ADMINISTRATIVE AMENDMENT
 FILE # 57-2018-00227 PROJECT # PR-2018-001346
 Per sheet A204:
 1. New roof line w/sky/light
 2. New signage
 E. B. [Signature] 13 Feb 2020
 APPROVED BY DATE

A MIXED USE
 DEVELOPMENT
 at alameda and
 san pedro ne.
 abq, nm

TIN CANALLEY
A CONTAINER DEVELOPMENT
6110 ALAMEDA BLVD NE
ALBUQUERQUE, NM
exterior elevations

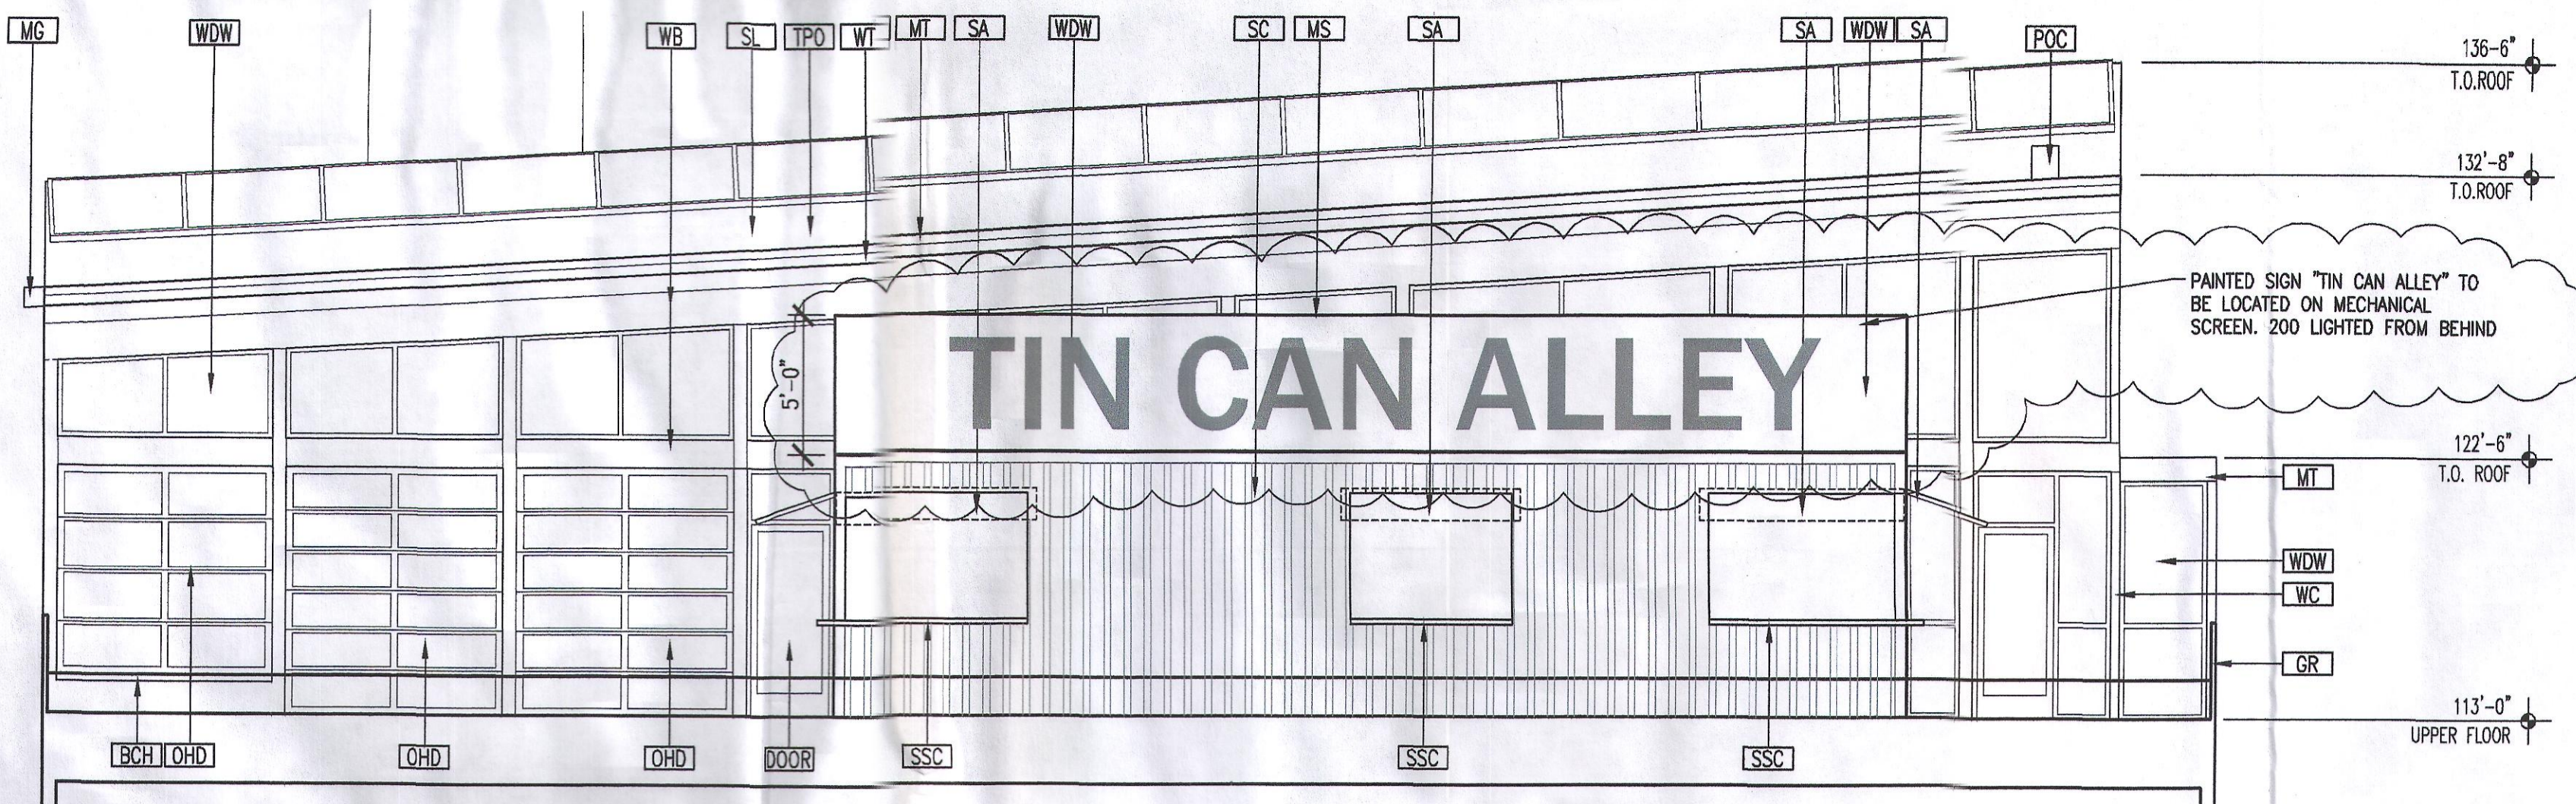
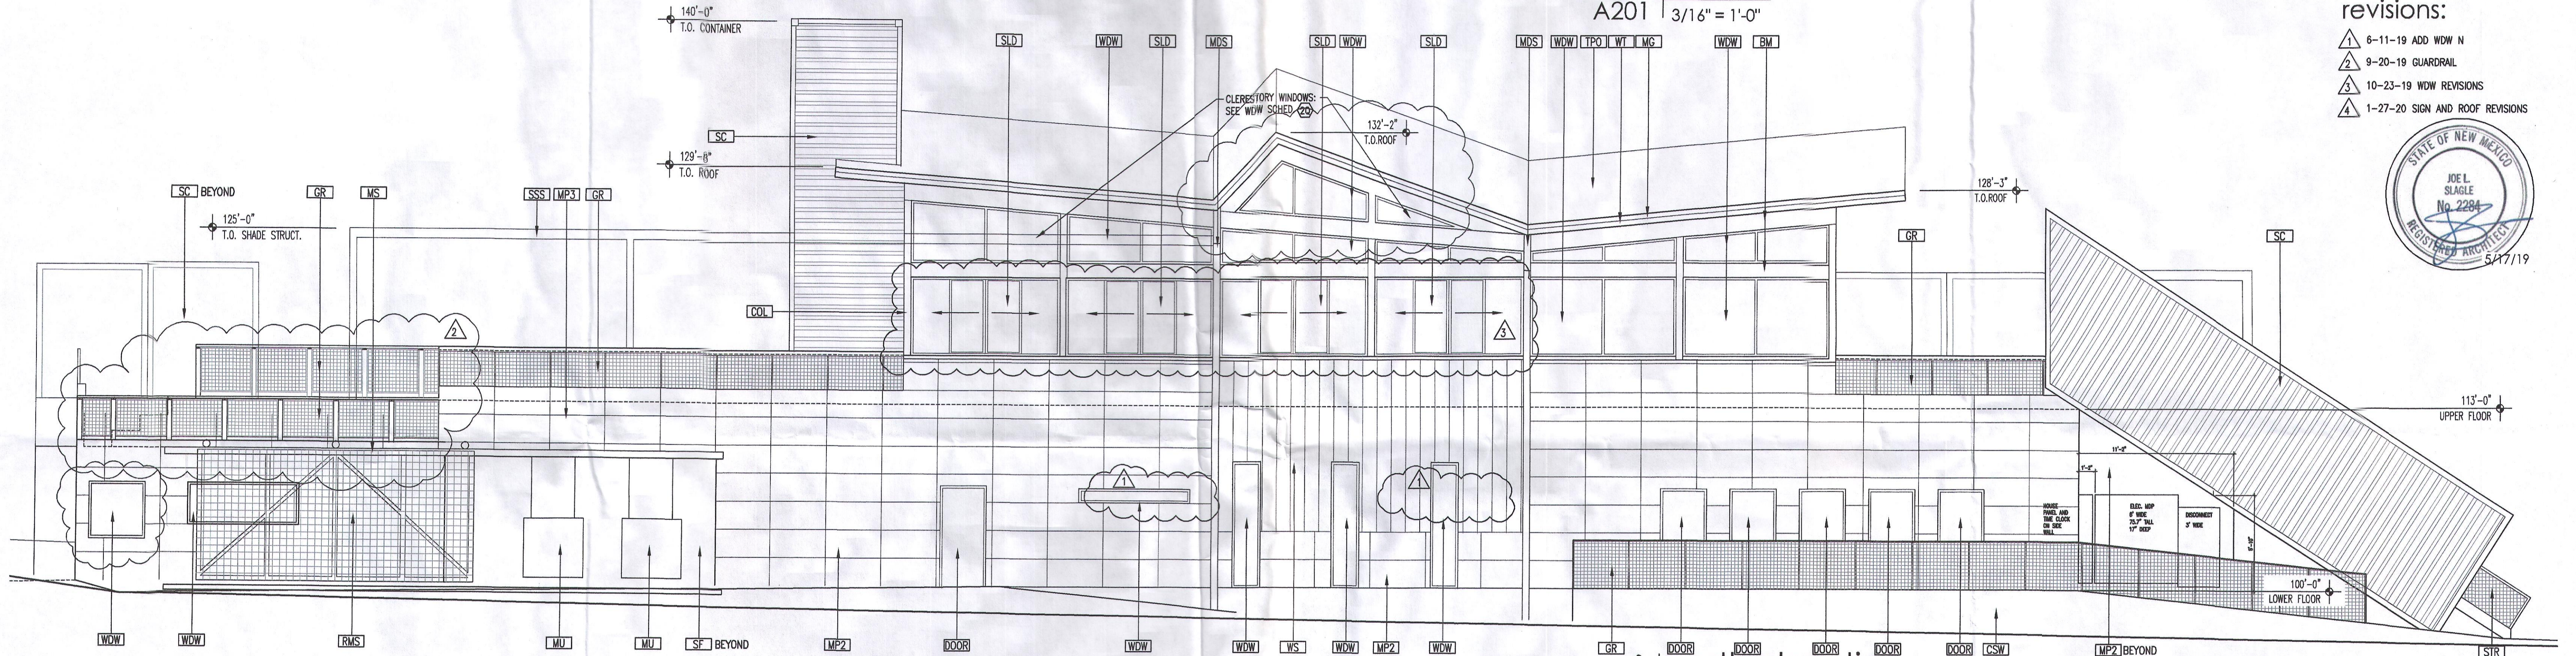
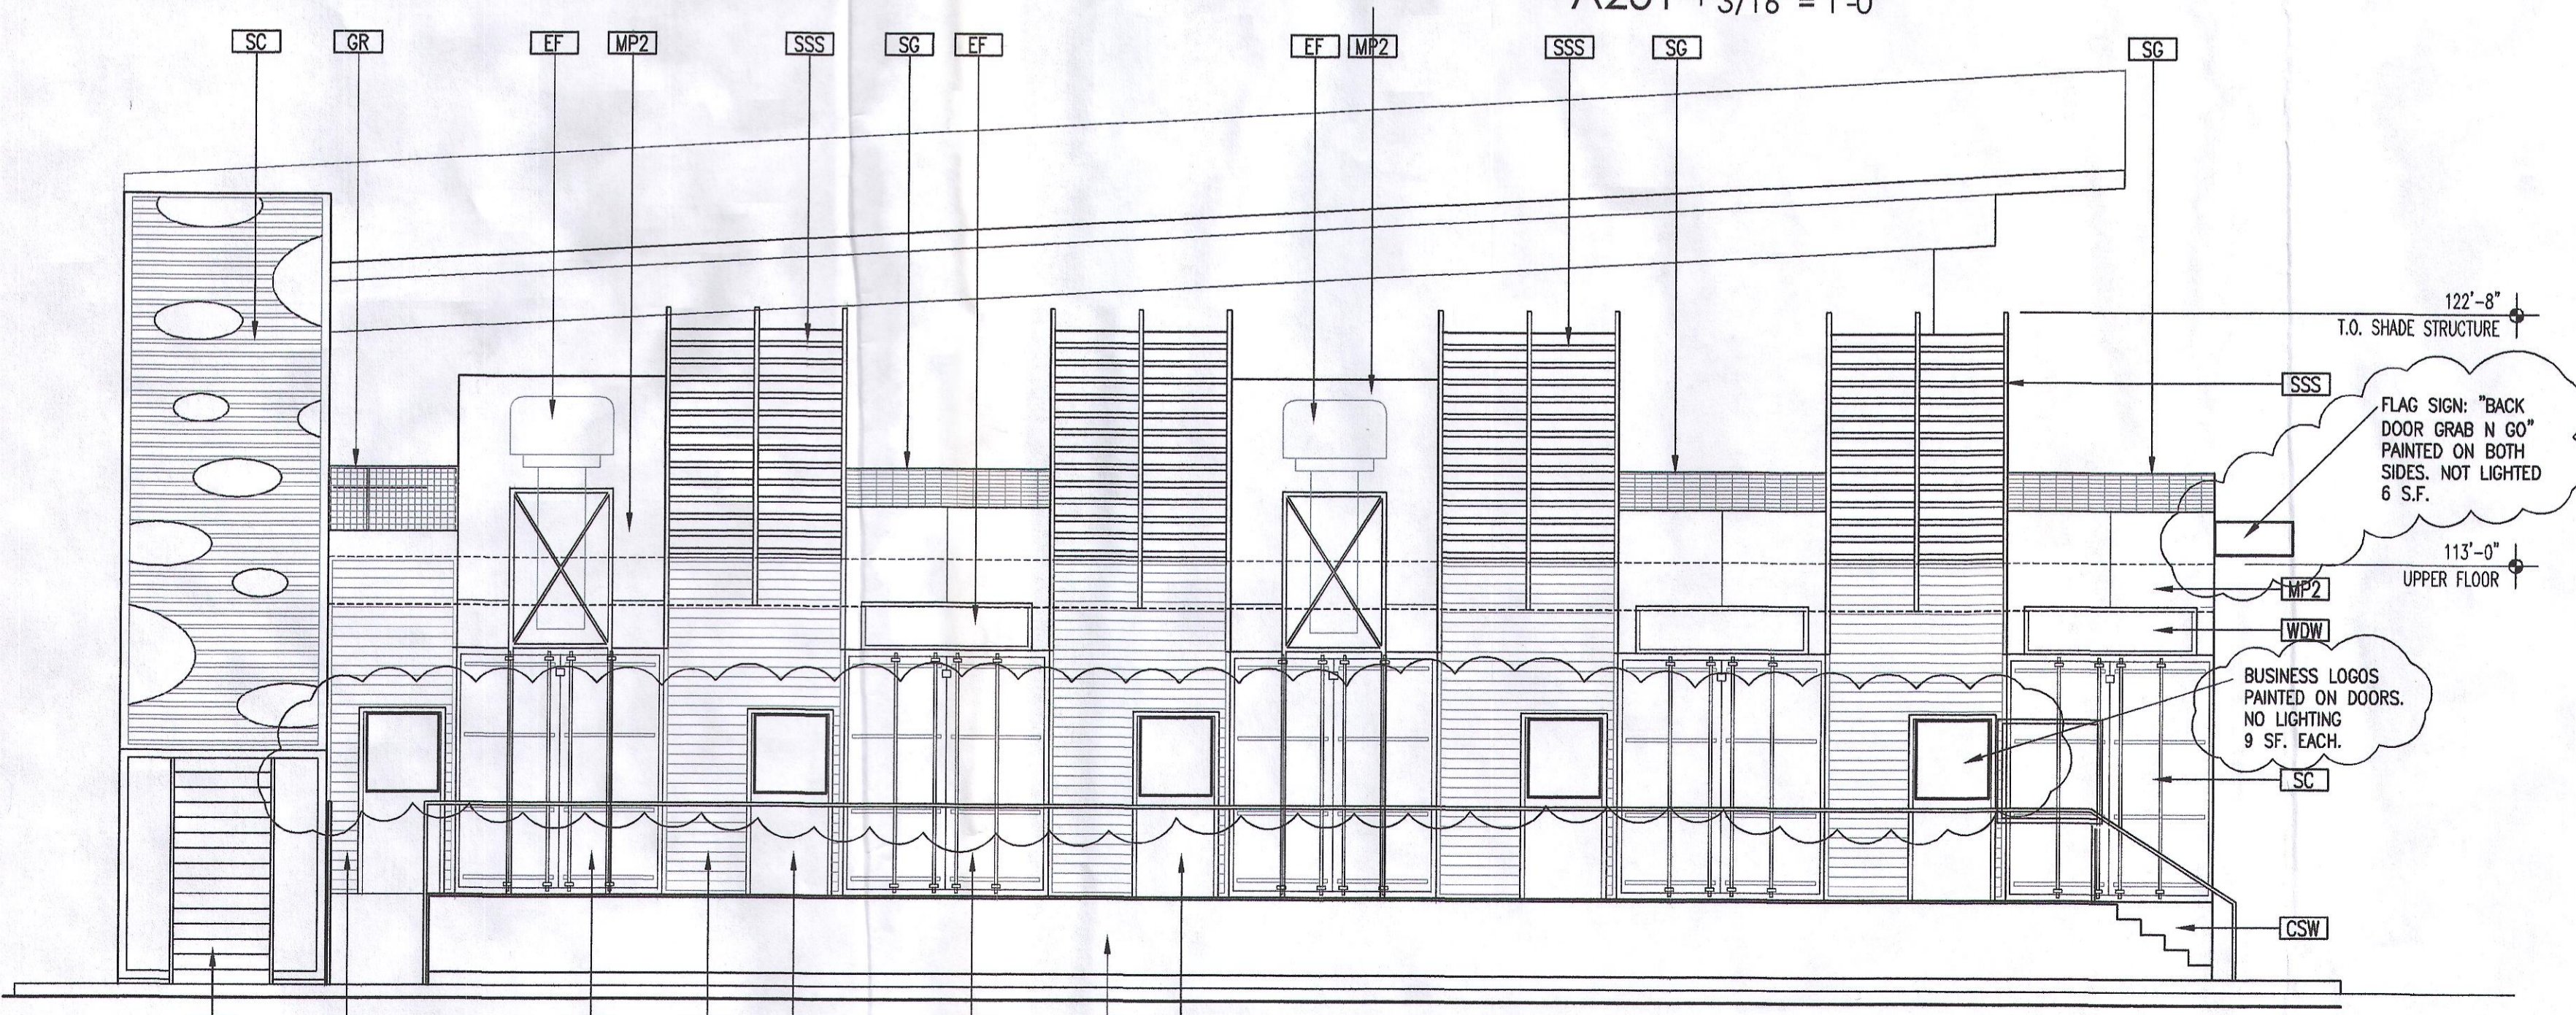
- revisions:
- △ 6-11-19 ADD WDW N
 - △ 9-20-19 GUARDRAIL
 - △ 10-23-19 WDW REVISIONS
 - △ 1-27-20 SIGN AND ROOF REVISIONS
